**Section 12A Application No. Y/I-DB/2
Area 6f, Lot 385 RP & Ext (Part) in D.D. 352, Discovery Bay**

Objection to the Submission by the Applicant on 27.10.2016

Comments on the Third Submission by Masterplan Limited dated 26th October 2016 to Amend Discovery Bay Zoning Plan for Rezoning the permissible use from staff Quarters to Flats At Area 6f, Discovery Bay

SECTION A-A

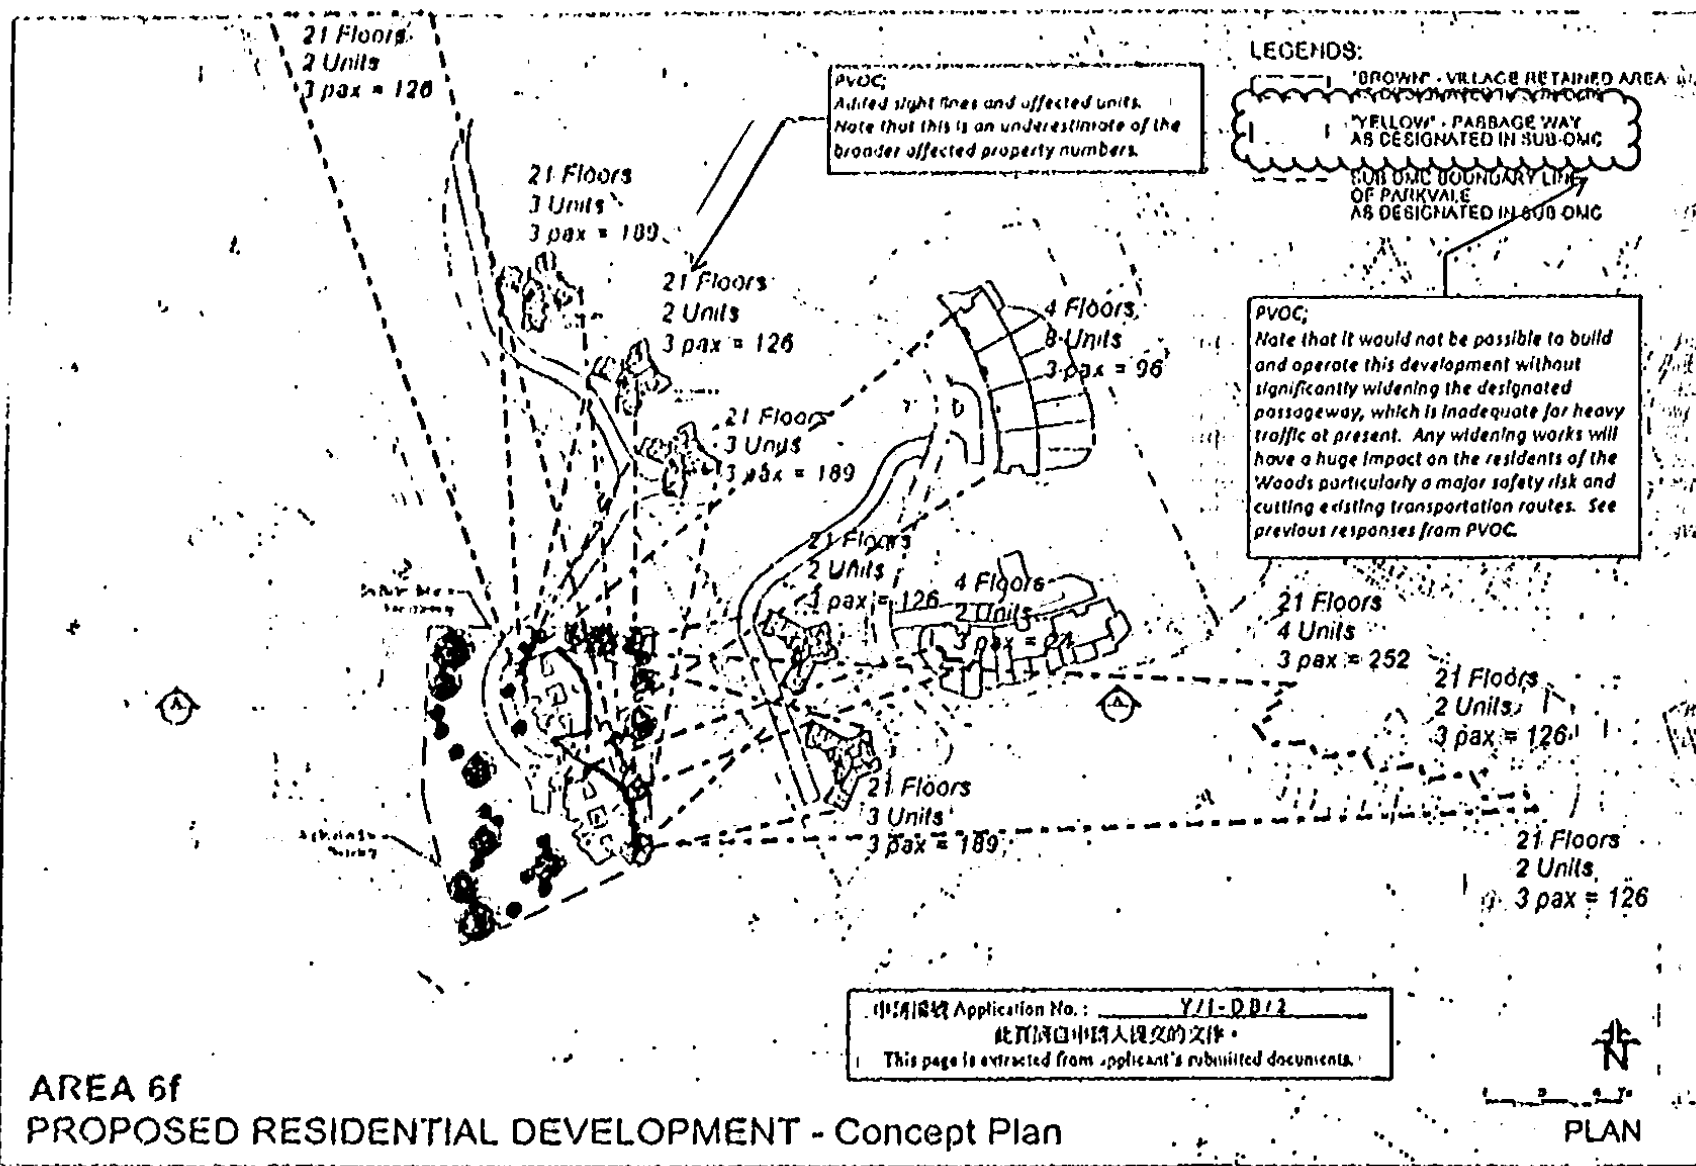
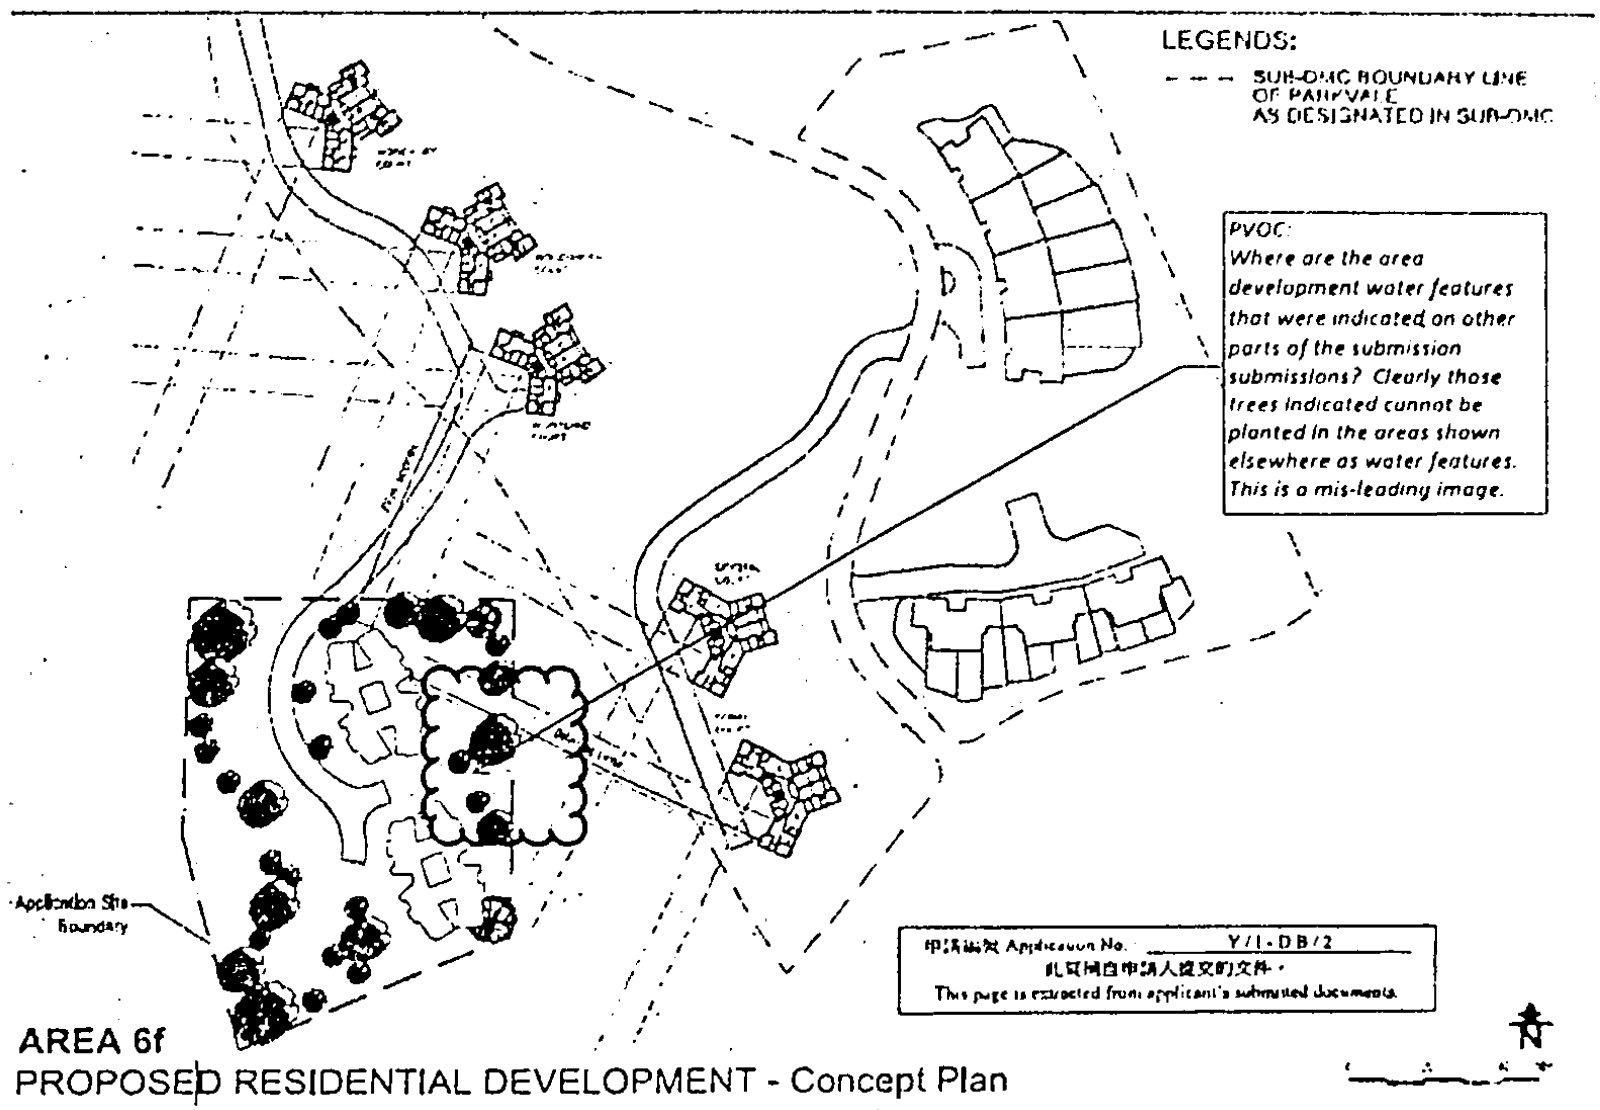
Approximate location of retaining wall. The excavation for construction will remove those highlighted trees.

Fig. 1.2.1 AFTER IMPRESSION FROM DISCOVERY BAY VALLEY ROAD

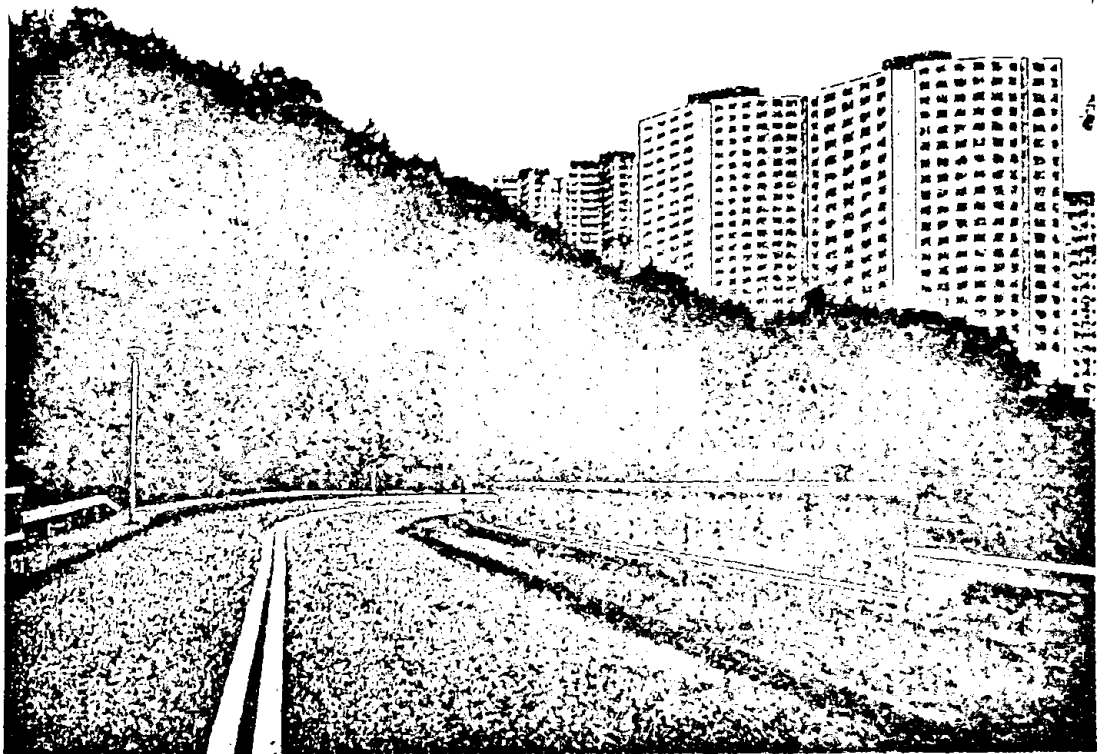
Why is this Photo mounting used there are very few incidents at this location who would be affected

B.1

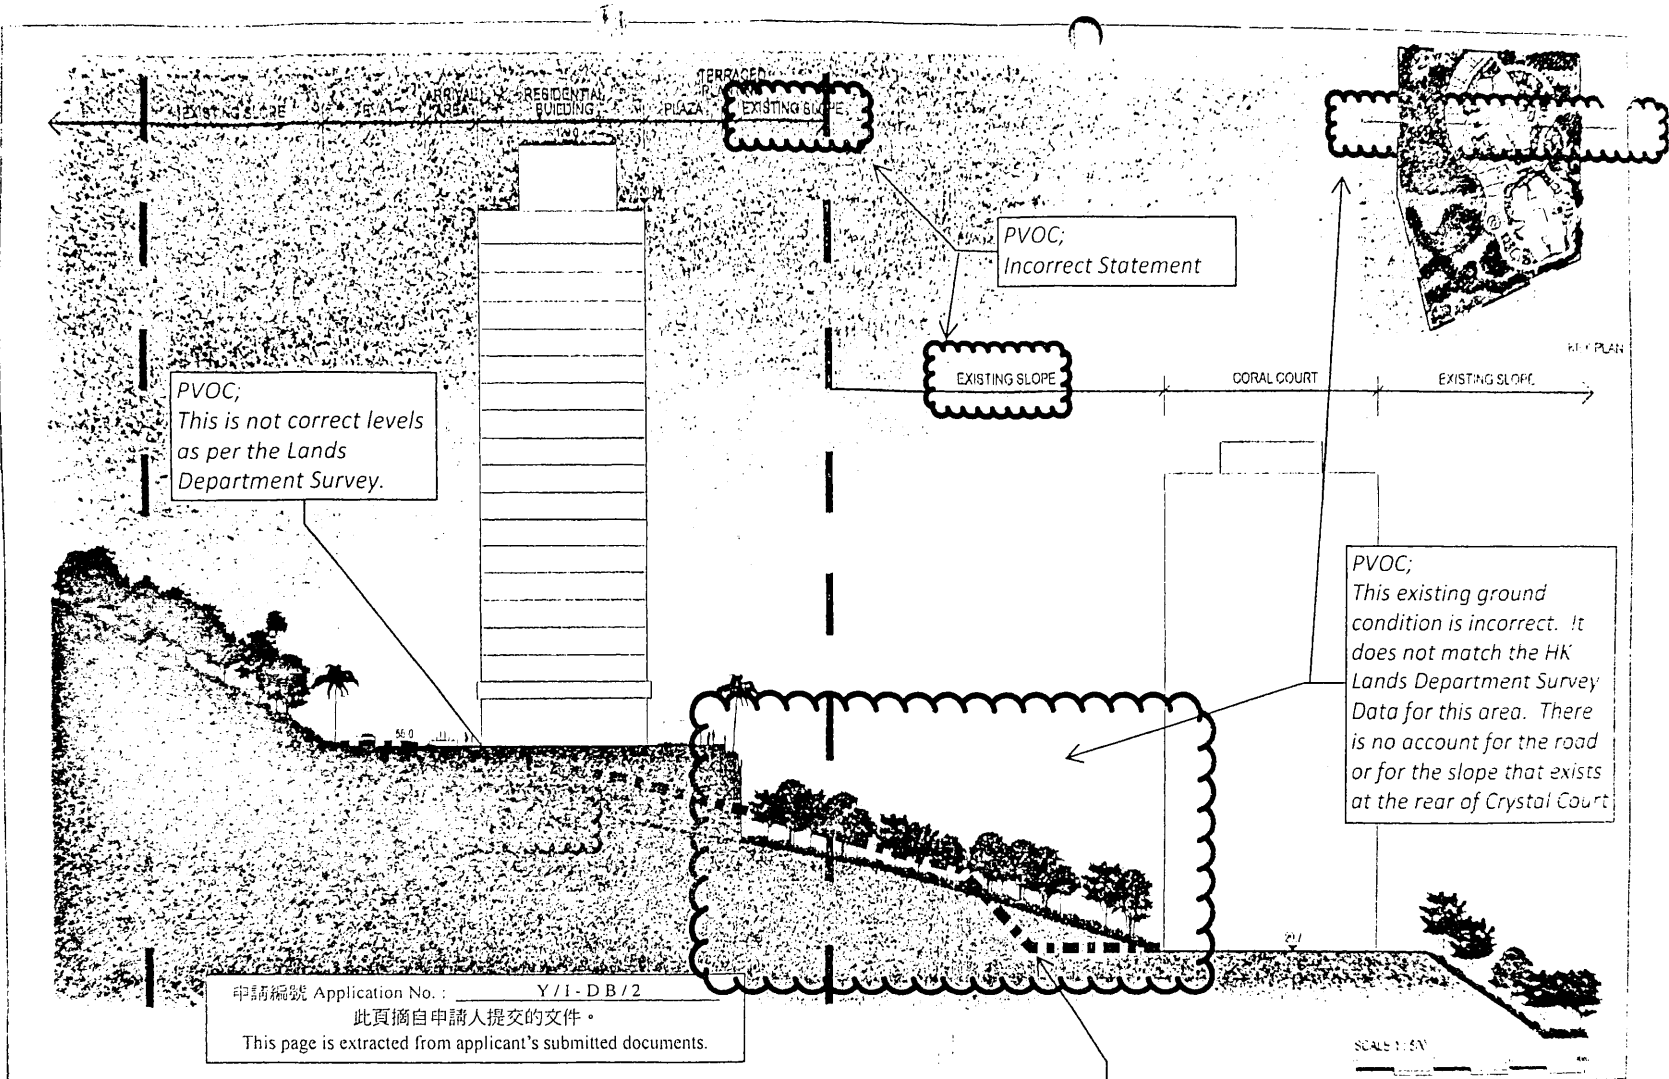
a. Tree Treatment Plan (Annex B, page A3) and Optimisation of Land Use figure B.1. The statement about existing tree groups to be retained is incorrect. These trees cannot be maintained based on the current plan, as there is a requirement for a large retaining structure and site formation that would not allow these trees to be left in place. Simple construction logistics would mean this would be very improbable. Also where is the approximate location of the retaining wall? The excavation for construction will remove those highlighted trees.

B.2

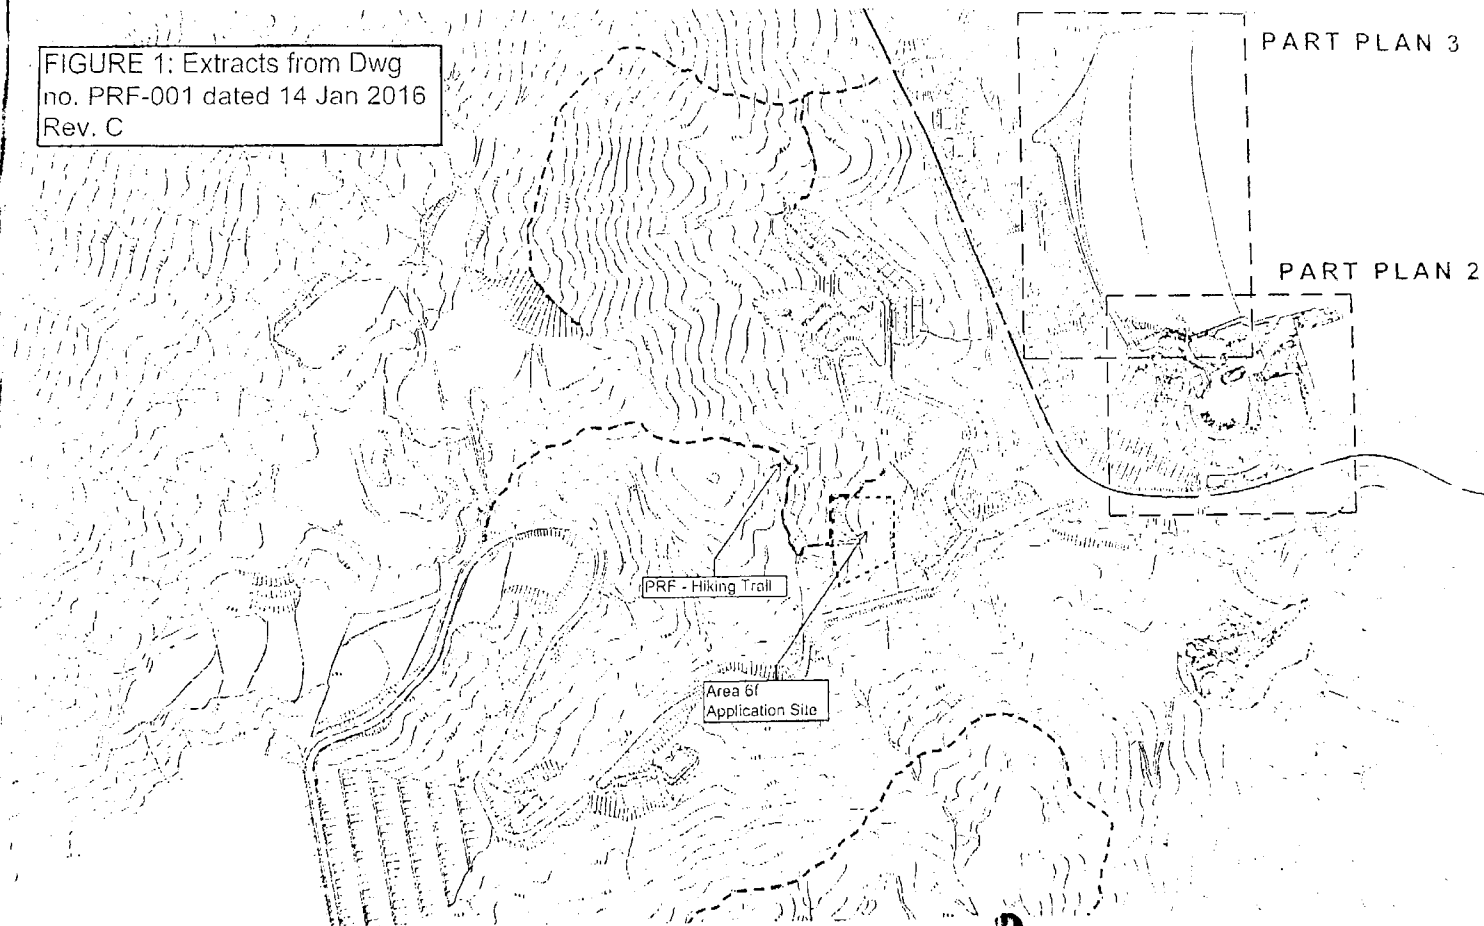
b. Optimisation of land use figure B.2. This figure includes incorrect statements about the existing slopes since the existing slope does not match the profile indicated by HKR's consultant: the existing slope profile shown in the figure does not reflect the correct levels as per the Lands Department Survey; the existing ground condition shown in the figure is incorrect since it does not match the Lands Department Survey data for this area. Furthermore, there is no account for the road or for the slope that exists at the rear of Crystal Court.

VP12. View West towards Application Site from D-Deck with Proposed Development

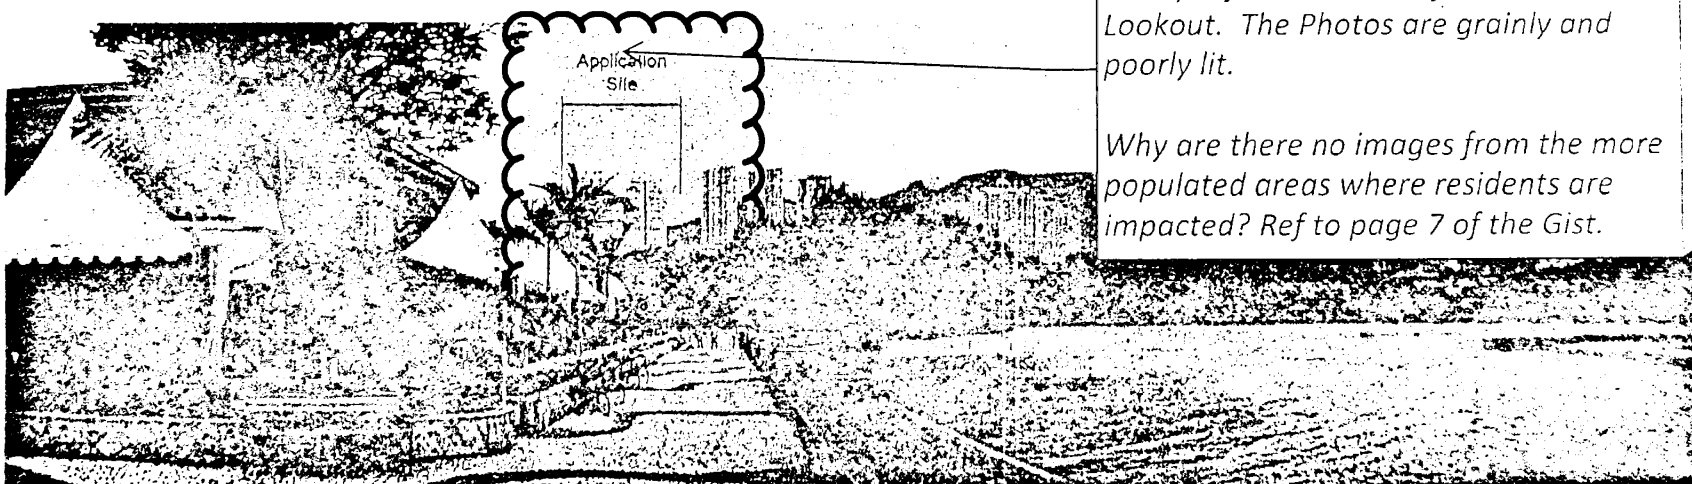
- e. Figure B.14 view from the D-Deck – why show this when there should be images from the more populated areas where residents are impacted, such as from Coral Court, Crystal Court, Woodbury Court, Woodgreen Court and Woodland.
